Access Compliance Report Public Rights-of-Way (Curb Ramps)

Main Street: SUNNY_SLOPE		Cross Street: MEANDERING_TRAIL		Location: S
ADA ID: RPRK211019131050	Ramp Type: Type 4 - Parallel	Initial Pass/Fail: Fail	Overall Compliance: No	Severity Score: 30

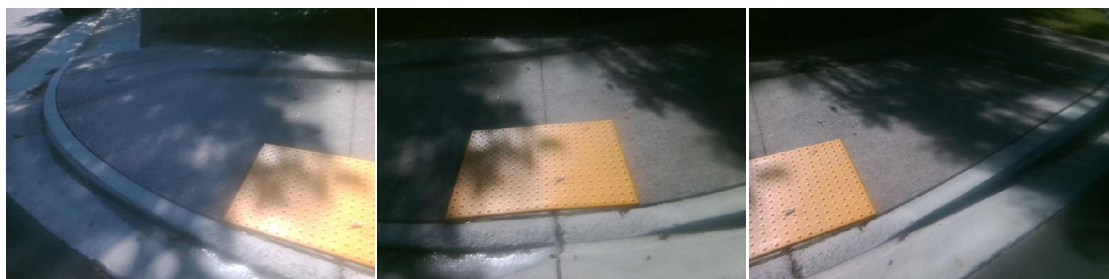
R204.3, R304.5.3, STD 1115

Remove & Replace Curb Ramp With Two New Directional Ramps or Equivalent.
